MISSOURI HIGHWAYS AND TRANSPORTATION COMMISSION 105 WEST CAPITOL JEFFERSON CITY, MO 65102 1-888-ASK-MODOT (1-888-275-6636)	
 	TEMPORARY TRAFFIC CONTROL DEVICES POST INSTALLATION DETAILS
	DATE EFFECTIVE: 4/1/2023 DATE PREPARED: 1/13/2023

### TEMPORARY TRAFFIC CONTROL DEVICES CHANNELIZERS AND DIRECTION INDICATOR BARRICADE

DATE EFFECTIVE: 4/1/2023  
DATE PREPARED: 1/13/2023  
SHEET NO. 616.10BB  
3 OF 9

U-CHANNEL POST DETAIL

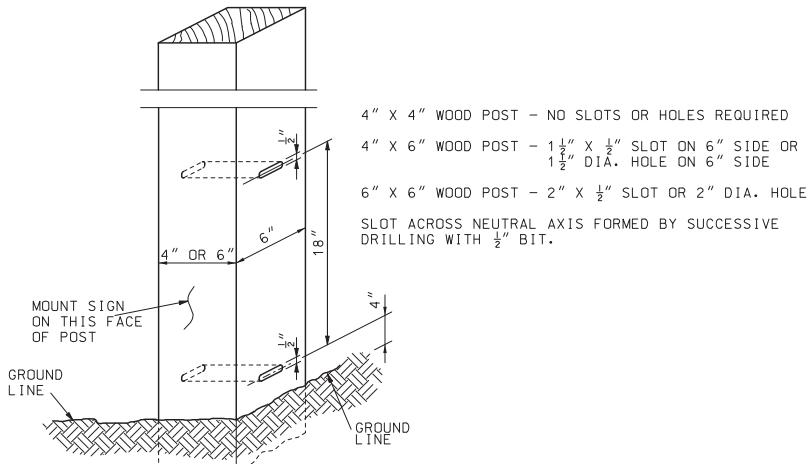
delete hold over from when use to have different splice option

### ADVANCE WARNING RAIL SYSTEM

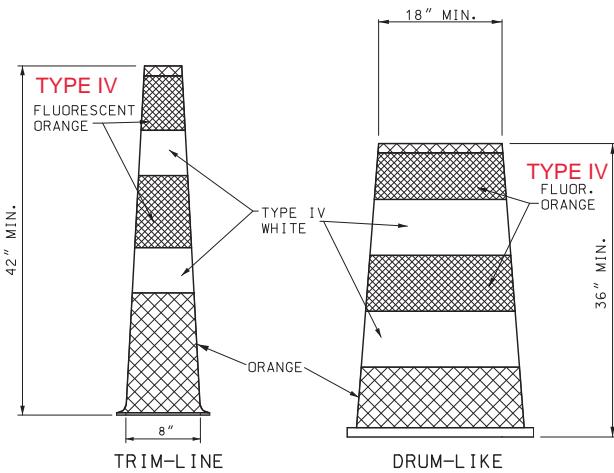
WHERE MARKING IS NOT PROVIDED ON THE BACKSIDE, STRIPS OF 3" WIDE ~~MODOT~~ TYPE IV ORANGE SHEETING MAY BE APPLIED TO THE ENDS OF EACH RAIL TO HELP DELINATE THE DEVICE.

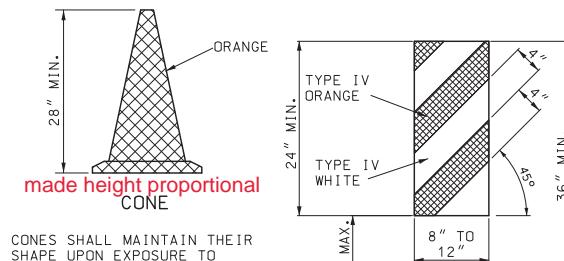
WHITE, ~~ORANGE~~, AND FLUORESCENT ORANGE REFLECTIVE SHEETING SHALL BE IN ACCORDANCE WITH SEC 1042.2.7.3.
